SUBJECT: SP19-062, Site Plan, Horseshoe Ridge Block 1 Lot 2 - Multi-Tenant Commercial Review Comments v3

PARKER MIXED-USE RETAIL

HESS ROAD & PARDEE
STREET
PARKER, COLORADO

1
A-1
PROPOSED NORTH ELEVATION (FRONT)
SCALE: 3/16" = 1'-0"

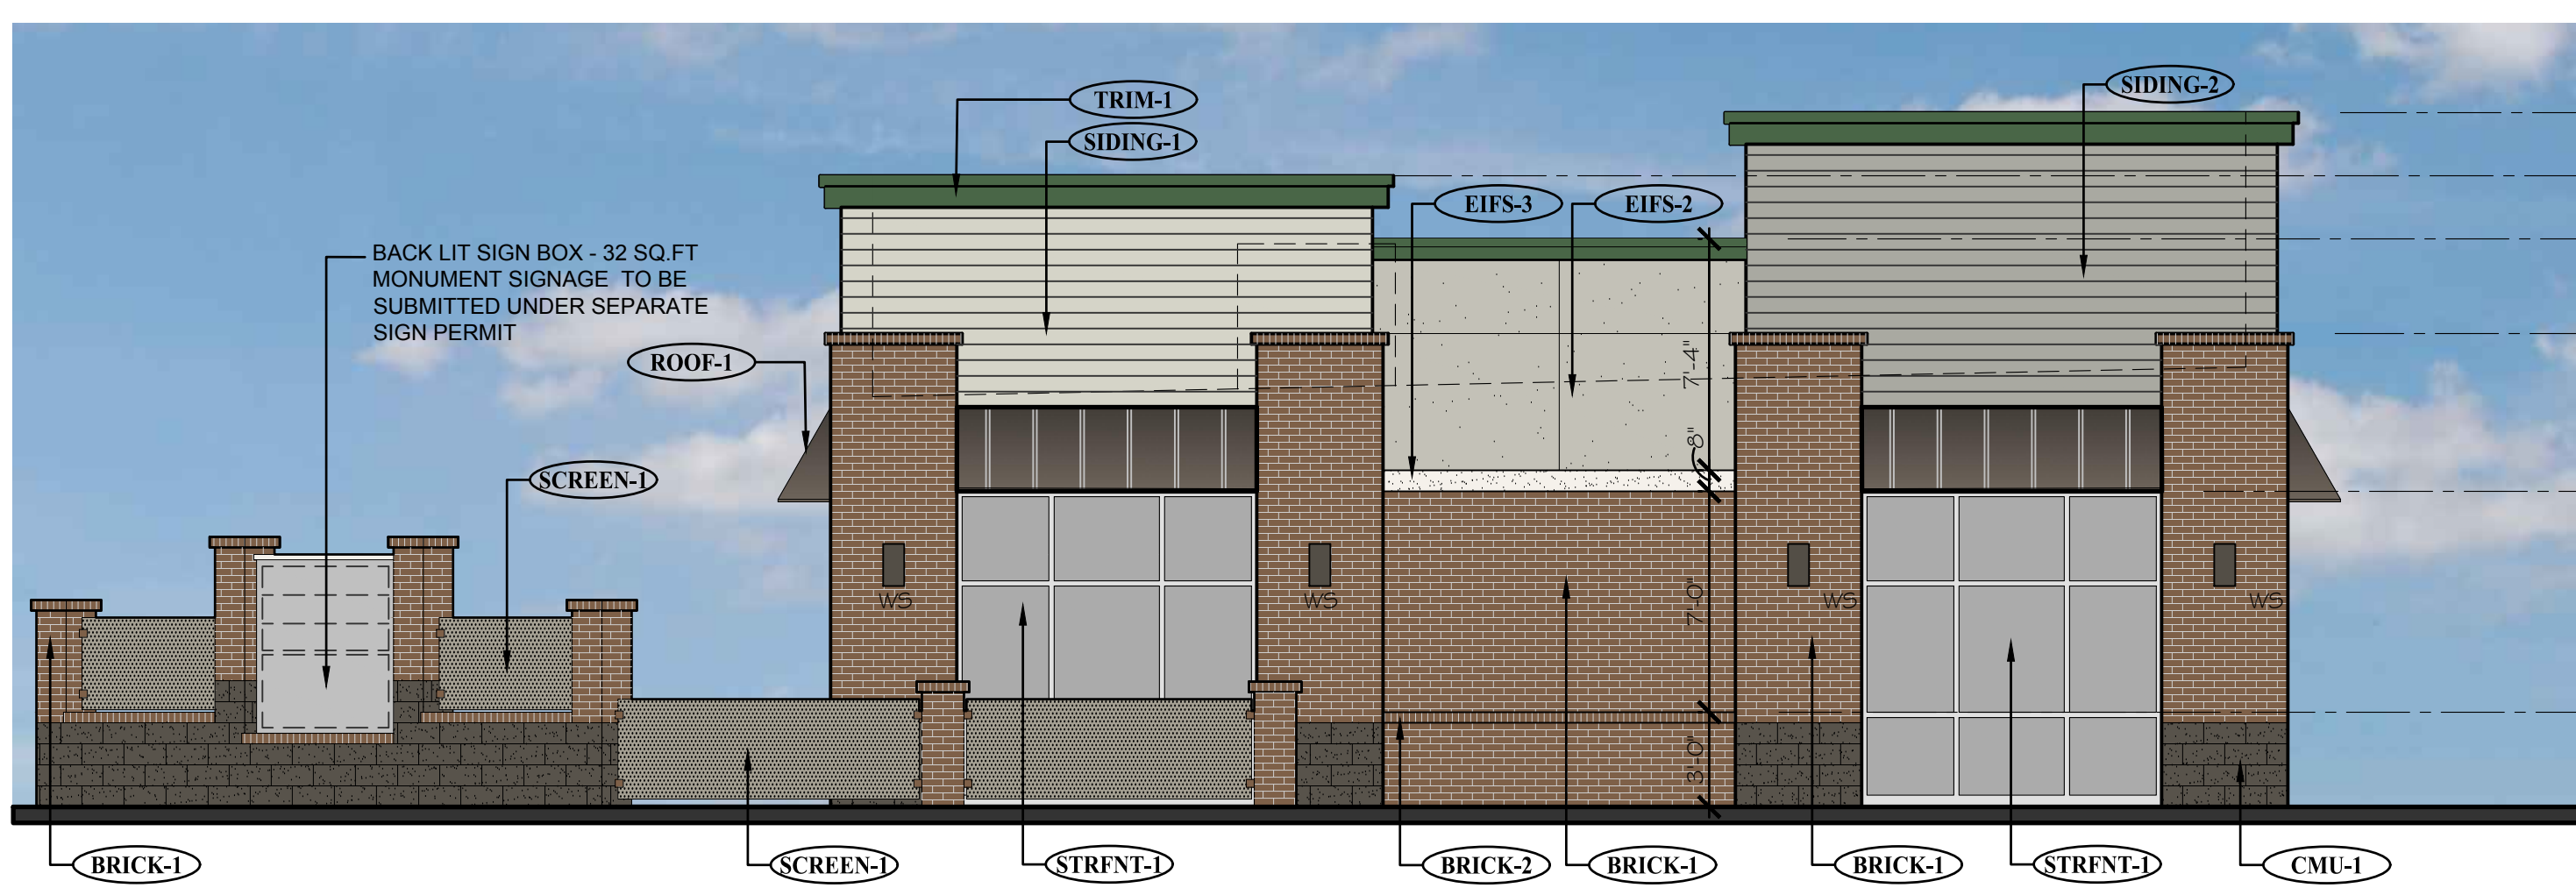
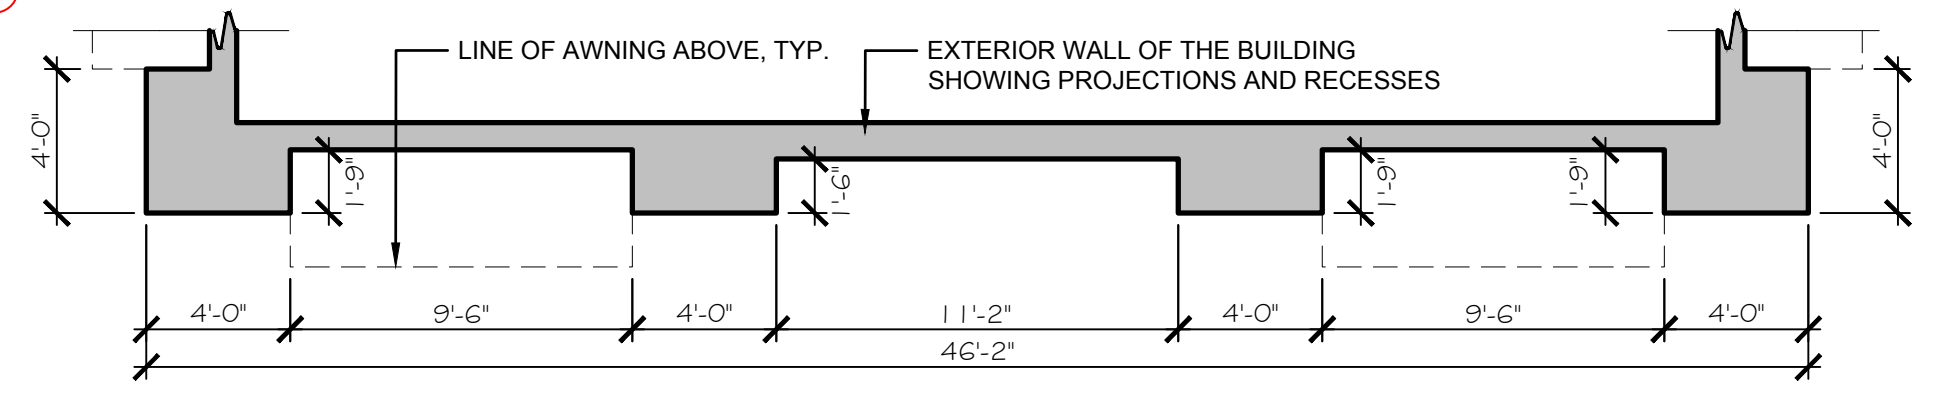
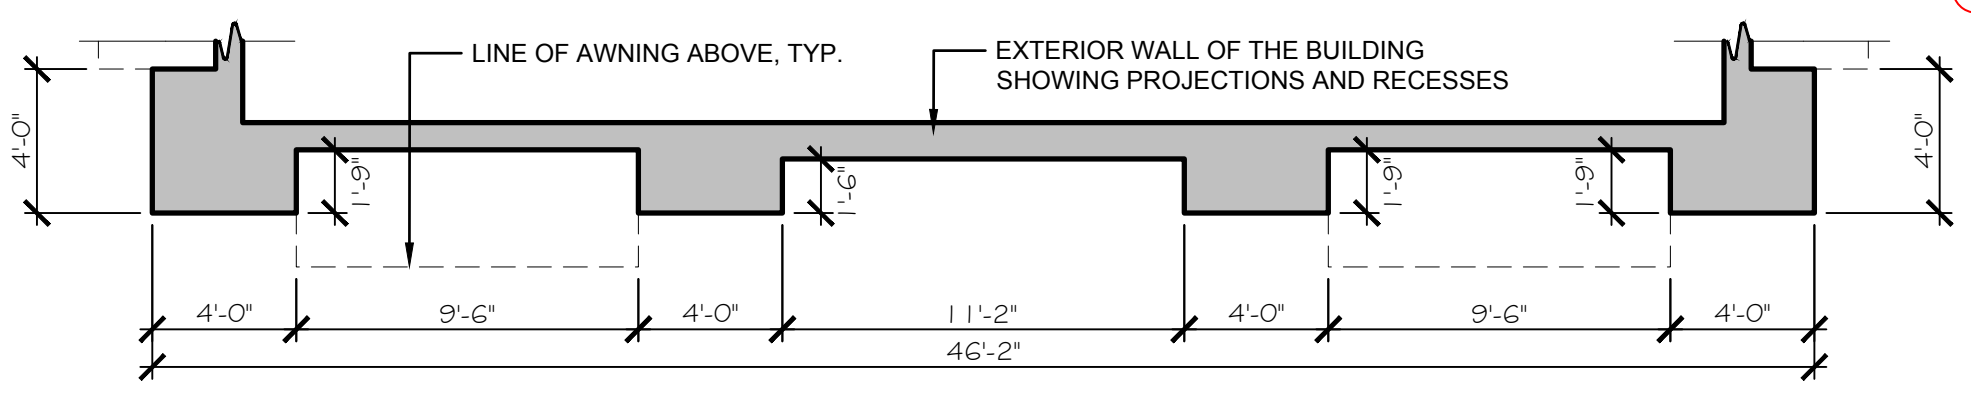
Remove comment. Do you have a floor plan for these tenant spaces? Will this proposed elevation work for kitchens, bathrooms, storage, etc.? Please call staff to discuss this elevation before resubmitting.

No glazing will be permitted on the north elevation for consistency.

We worked directly with Brie on this comment to address properly. The glazed area on this elevation is because of the fire riser room in this portion of the building.
For the rear/south elevation we worked with Brie on the transparent glass and the elevations included in the submittal reflect the requests from Brie and the Planning Director.

1 PHOTOMETRIC SITE PLAN
scale: 1"=20'-0"
NORTH

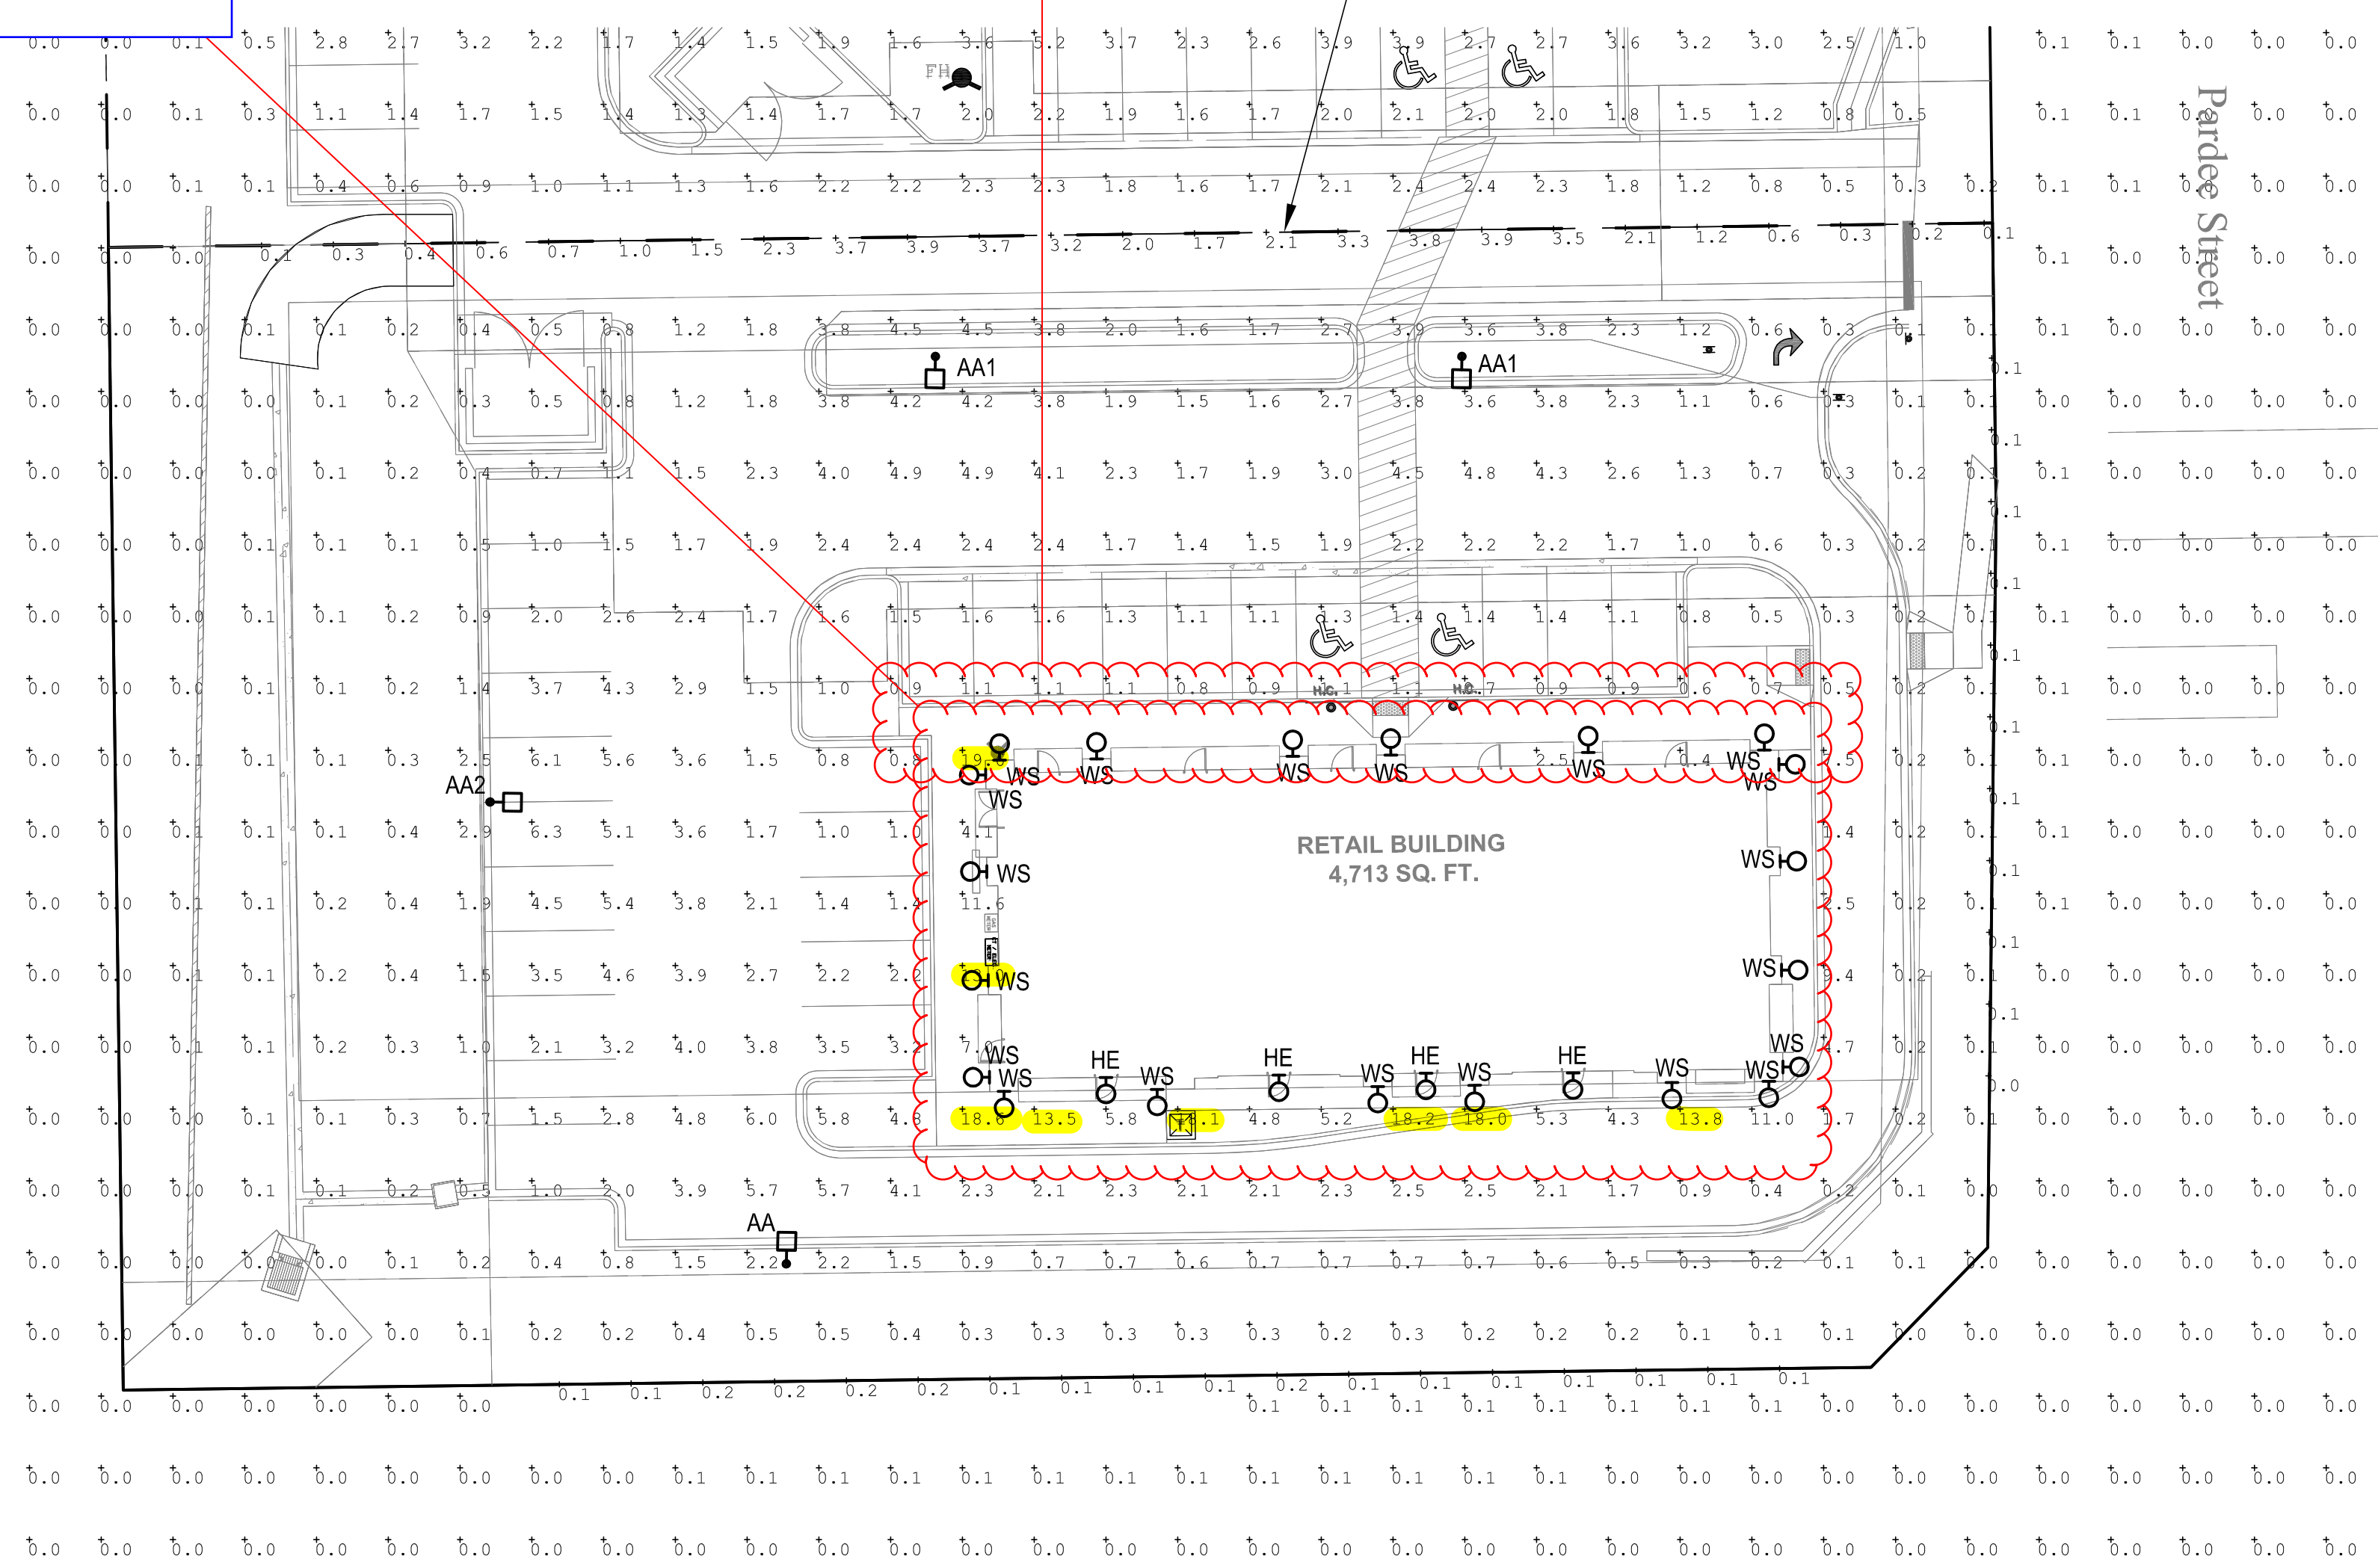
Per Section 13.10.140 (e)(14) The maximum illuminance on any residential or nonresidential site (not including any site with a qualifying principal display area) is twelve point zero (12.0) foot-candles, maximum installed illuminance. Please adjust accordingly.

Provide the foot candles along the pedestrian walk way.

Per Section 13.10.140 for pedestrian safety and orientation, medium activity lots the maximum Uniformity Ratio (average to minimum) is 3:1. Please adjust accordingly.

Per Section 13.10.140 for pedestrian safety and orientation, medium activity lots the maximum Uniformity Ratio (maximum to minimum) is 10:1. Please adjust accordingly.

This has been corrected in the updated plans

Provided on the updated plans

THE LIGHT LEVELS EXCEED AT THE PROPERTY LINE FOR THE SHARED ACCESS ISLE ONLY TO PROVIDE ADEQUATE LIGHTING FOR VEHICLE AND PEDESTRIAN SECURITY BETWEEN BOTH PROPERTIES. ALONG THE PROPERTY LINE, THE MINIMUM FOOT CANDLE PROVIDED IS 0.1 AND MAXIMUM FOOT CANDLE PROVIDED IS 3.9. THIS MEETS THE MAXIMUM ALLOWED ILLUMINANCE FOR NON-RESIDENTIAL SITE

Both comments have been addressed

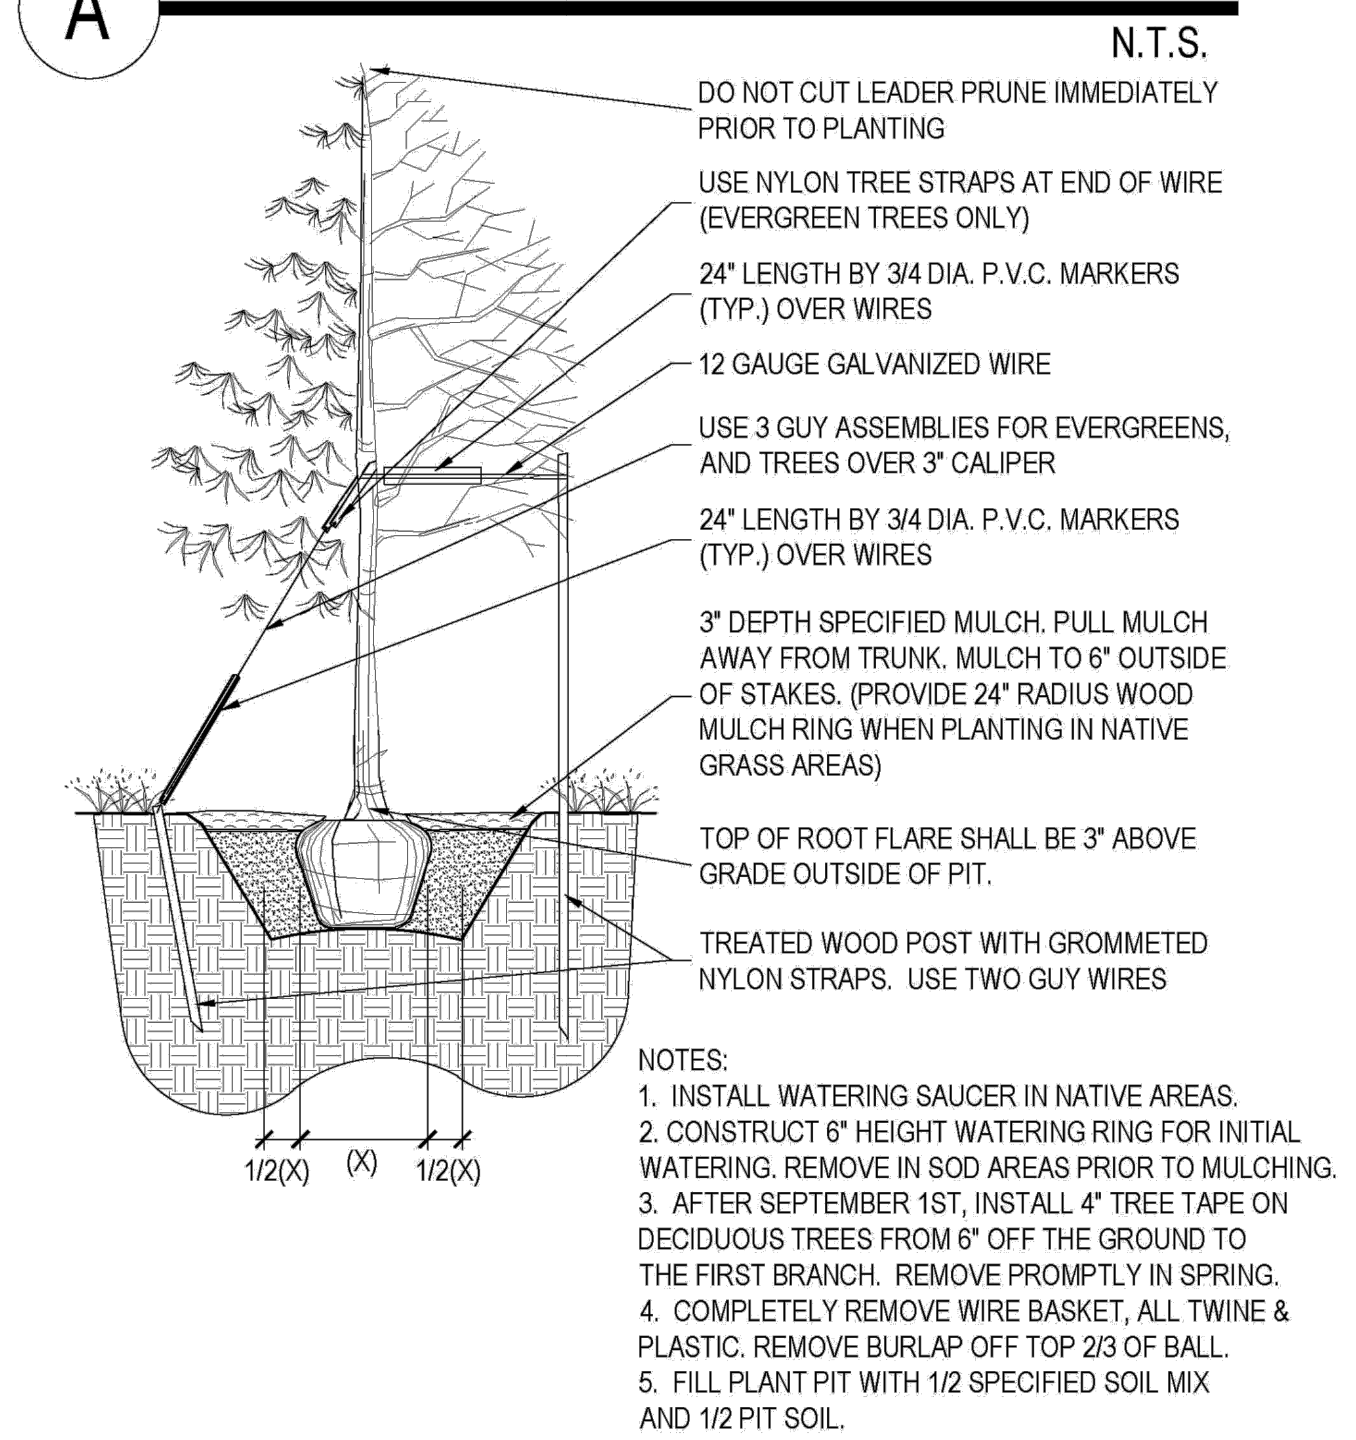
This note is confusing. Only show the number of shrubs being provided and do not count perennials towards the number of shrubs provided.

This line item in the table is confusing. It might be more clear if for the trees and shrubs provided only show what is being provided. Add a column from ornamental grasses if those are being provided in lieu of shrubs. Then add a foot note to explain what is being substituted for what in each column.

One (1) ornamental grass in a five-gallon container or three (3) ornamental grasses in one-gallon containers may be substituted for one (1) shrub per Section 13.06.070. Please update accordingly.

Note is clarified in updated plans

Note is clarified in updated plans

Note is clarified/updated in updated plans
